#### MCLEOD FAMILY DIVISION SUBDIVISION

APPLICATION NUMBER \_\_\_\_\_4 DATE \_\_September 6, 2018

## **DETAIL SITE PLAN**

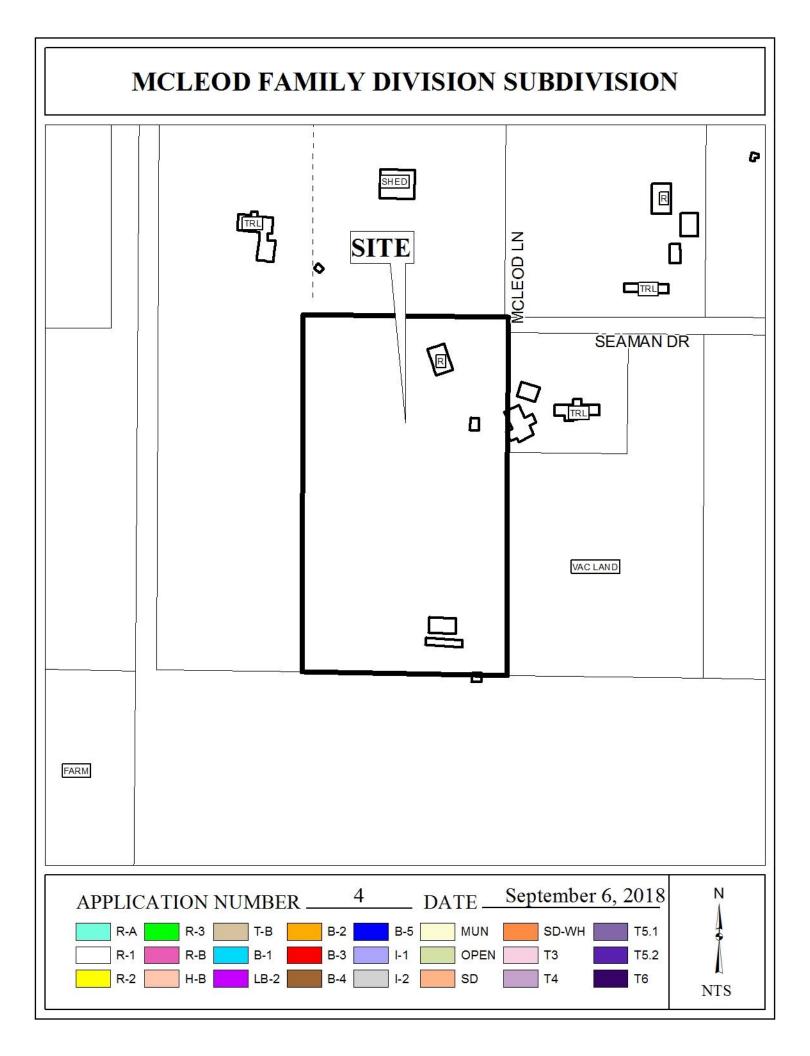
The 25' minimum building setback is not illustrated on the preliminary plat, as required by Section V.D.9. of the Subdivision Regulations. As such, revision of the plat to illustrate the 25' minimum building setback along Seaman Drive where each lot is at least 60' in width should be required, if approved.

Irrespective of the design of the lots, they each meet the minimum size requirements for lots served by public water and individual septic systems; however, their sizes are labeled only in acres and not in square-feet. As such, revision of the plat to indicate the size of each lot in both square-feet and acres should be required, if approved; or, provision of a table on the Final Plat providing the same information may suffice.

The vicinity map on the preliminary plat is hand drawn and may not properly reflect the location of the proposed subdivision. As such, revision of the vicinity map to properly identify the location of the proposed subdivision should be required, if approved.

1) retention of the 60' right-of-way along Seaman Drive;

2) placement of a note on the Final Plat stating maintenance of the private road is the responsibility of the property owners and not Mobile County;

- 3) placement of a note on the Final Plat stating Lot A is limited to one (1) curb cut to Seaman Drive, and Lot B is limited to two (2) curb cuts to Seaman Drive, with their sizes, locations, and designs to be approved by Mobile County Engineering and conform to AASHTO standards;

- 4) revision of the plat to illustrate the sizes of each lot in both square-feet and acres, or provision of a table on the plat providing the same information;

- 5) revision of the vicinity map to properly identify the location of the proposed subdivision;
- 6) placement of a note on the Final Plat stating that any lots which are developed commercially and adjoin residentially developed property must provide a buffer, in compliance with Section V.A.8. of the Subdivision Regulations;

- 7) placement of a note on the Final Plat to comply with the Mobile County storm water and flood control ordinances: "Must comply with the Mobile County Flood Damage Prevention Ordinance. Development shall be designed to comply with the storm water detention and drainage facility requirements of the City of Mobile storm water and flood control ordinances, and requiring submission of certification from a licensed engineer certifying that the design complies with the storm water detention and drainage facility requirements of the City of Mobile storm water and flood control ordinances prior to the issuance of any permits."; and,
